**Technical Service
Bulletin**

Date: 2010-12-10	SAP DIR #: 20012096
Subject:	TSB – CP50 & CP50 Plus V01.10.01 SOFTWARE RELEASE
CAR Number:	N/A
Distribution Scope:	WA Internal WA Technical Support, Product Service, & International Service Centers
Product(s) Referenced:	CP50 and CP50 Plus Electrocardiographs
SW Version:	ALL
Serial No. / Lot Code:	N/A
Summary:	The Welch Allyn Diagnostic Cardiology Team is pleased to announce a new version of software for the CP50 and CP50 Plus electrocardiographs. This version 01.10.01 software is a general maintenance release that incorporates several improvements outlined below. This update incorporates all prior updates.
Issue:	Based on MPD SOP-20211, the software update is classified as continuing engineering project, which is governed by SOP-20213.

➤ **User interface improvement: Date & Time entry**

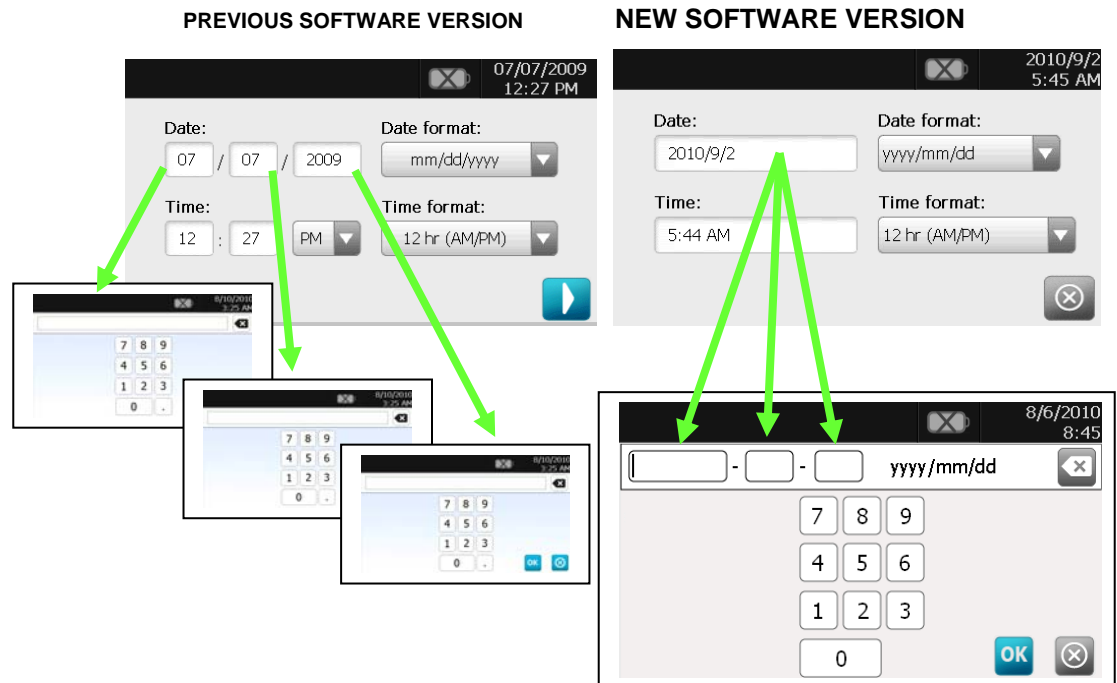
During an Auto ECG procedure, the age or date of birth of the patient is requested. Previously, we needed to tap on fields individually such as day, month, and year to enter the date (multiple tapping). The improved interface will allow for these fields to be filled from a single screen. This change applies to the system's regional date settings as well. Similarly, the clock setting will allow the hour and minute fields to be filled from a single screen. Samples of the new user interface are shown in the images below.
